Model: K-C4/PT-D4	Date: 22-Jan-13	No.: RD158023b
-------------------	-----------------	----------------

Subject: Firmware Release Note: ARDF DF2020		Prepared by: A. Ishida	
From: 1st Tech Service Sect., MFP/Printer Tech Service Dept.			
Classification:	<input type="checkbox"/> Troubleshooting <input type="checkbox"/> Mechanical <input type="checkbox"/> Paper path <input type="checkbox"/> Product Safety	<input type="checkbox"/> Part information <input type="checkbox"/> Electrical <input type="checkbox"/> Transmit/receive <input checked="" type="checkbox"/> Other (Firmware)	<input type="checkbox"/> Action required <input type="checkbox"/> Service manual revision <input type="checkbox"/> Retrofit information <input checked="" type="checkbox"/> Tier 2

Subject: Firmware Release Note: Main		Prepared by: Y.Kuwabara	
From: 2nd Tech Service Sect., MFP/Printer Tech Service Dept.			
Classification:	<input type="checkbox"/> Troubleshooting <input type="checkbox"/> Mechanical <input type="checkbox"/> Paper path <input type="checkbox"/> Product Safety	<input type="checkbox"/> Part information <input type="checkbox"/> Electrical <input type="checkbox"/> Transmit/receive <input checked="" type="

Mylar Replacement Procedure:

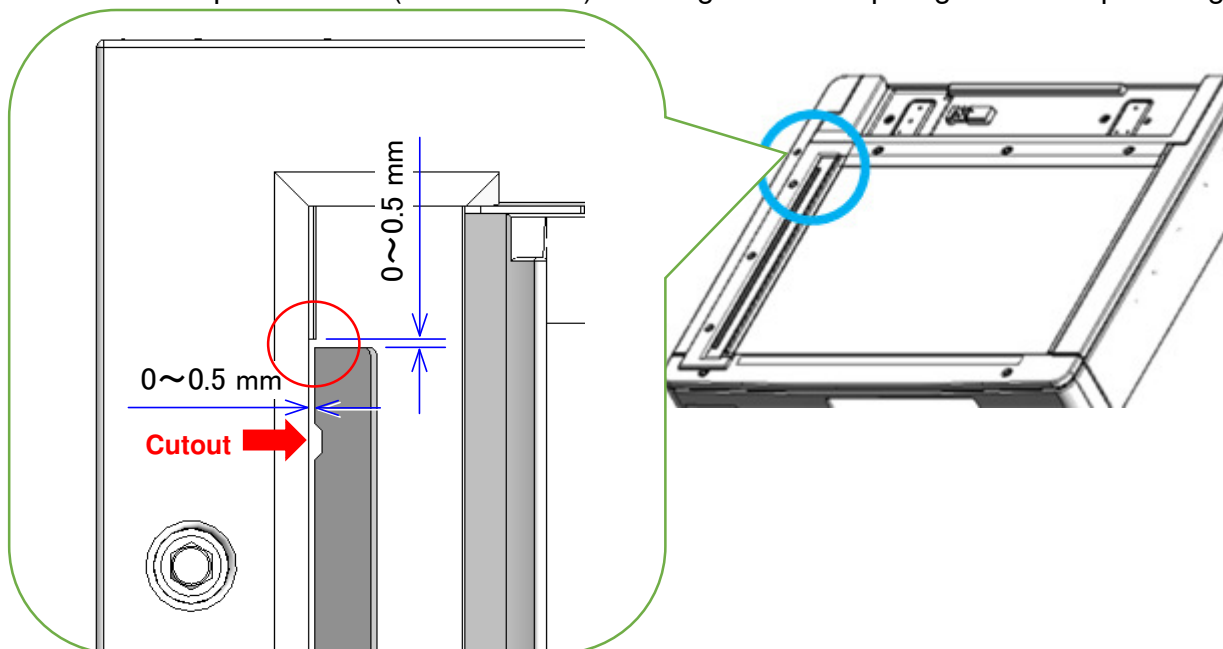
When installing the Document Feeder (DF2020), replace the mylar originally attached to its exposure glass with the new mylar included as an accessory to the Document Feeder. Scan quality, especially at the trailing edge of the original, is better with the new mylar.

- If the mylar could not be attached properly, remove it and attach a new one at your next visit.
- Without the new mylar, feeding thick paper for more than 90K pages may cause jitter.

1. Remove the originally attached mylar from the document feeder exposure glass.
2. Wipe the document feeder exposure glass with cloth.
3. Attach the new mylar.
 - The cutout in the mylar faces to the left.
 - Set the top left corner (circled in red) flush against the top edge of the exposure glass.

19. Master Eject Unit 1 (C282)

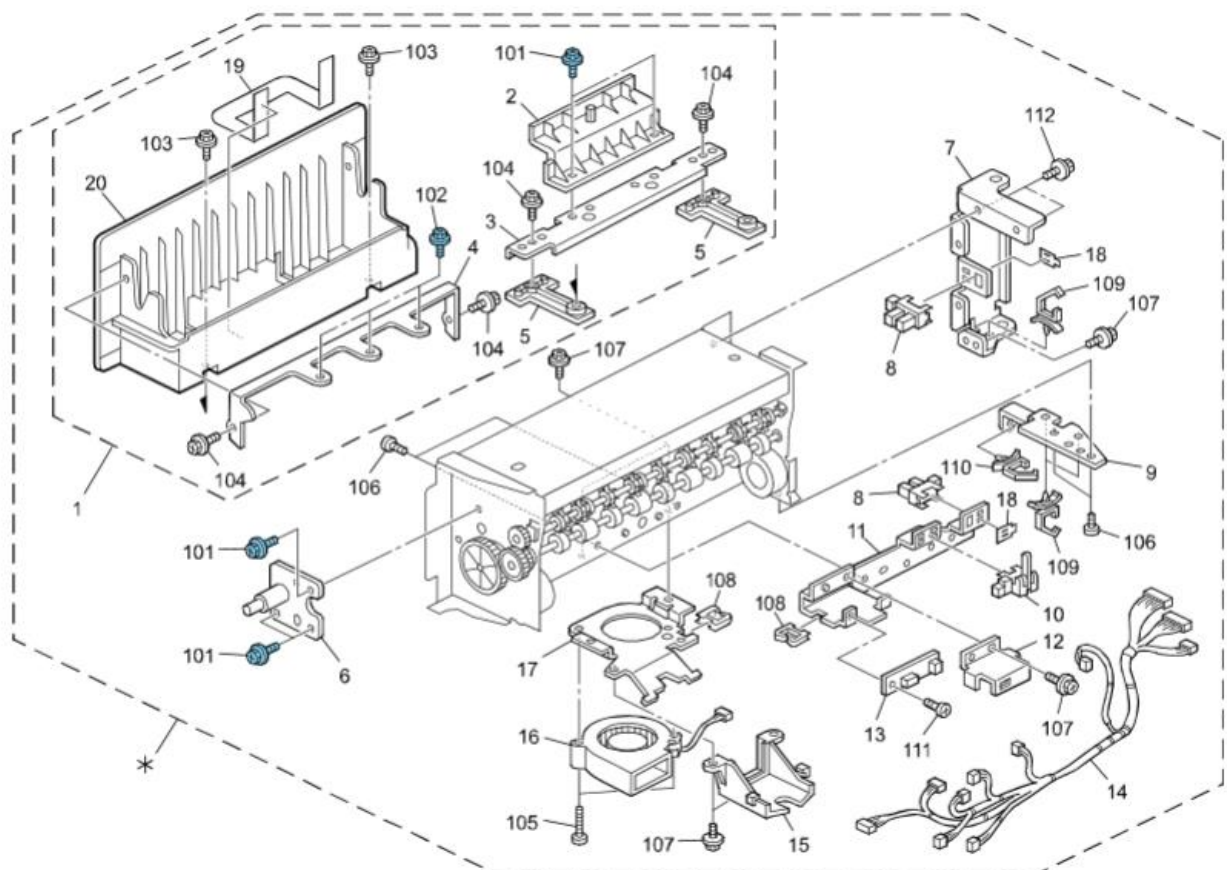
Please delete the following parts from the Parts Catalog.

Old part number	New part number	Description	Q'ty	Int	Page	Index	Note
C2753450	-	Frame:Master Ejection Unit:Ass'y	1-0	-	45	*	Deleted
C2821905	-	Plotter:Fix:B4:Ass'y	1-0	-	27	*	Deleted
C2821911	-	Plotter:UNI:LG	1-0	-	27	*	Deleted
